## PŘÍKAZ K ZACHOVÁNÍ LETOVÉ ZPŮSOBILOSTI

**Číslo: A- 2005-003**

**Diamond Aircraft Industries GmbH**  
model DA 42

Exchange of the Wing Stub Safety Walks,  
Revision of the Airplane Flight Manual  
Single Engine Rate of Climb/Descent

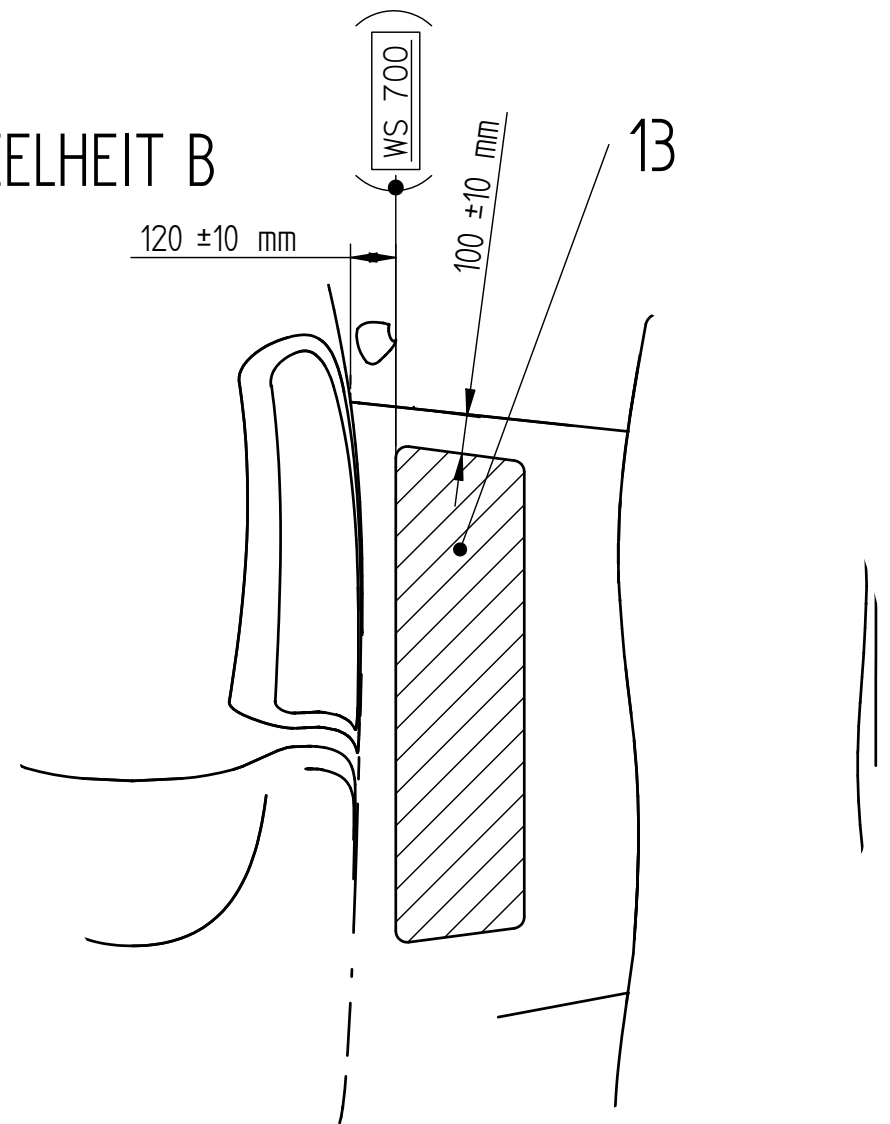
- a Remove Safety Walk Series 300, color grey – coarse surface (surface roughness equal to sandpaper with grid 40). For replacement refer to AMM, Chapter 11-00.
- b Install new Safety Walk D60-1127-10-51 Rev. “a” or later issue (surface roughness equal or finer than sandpaper grid 100) according to drawing D60-1120-20-00SB, latest effective revision. For replacement refer to AMM, Chapter 11-00.
- c Remove AFM-TR-MÄM-42-070, page 5-18a, and AFM-TR-MÄM-42-103, page 5-18b.
- d Mark AFM page 5-18 as superseded.
- e Incorporate Temporary Revision TR-MÄM-42-111/a into the AFM.
- f MSB 42-005 becomes obsolete with compliance to MSB 42-006/1 or later.
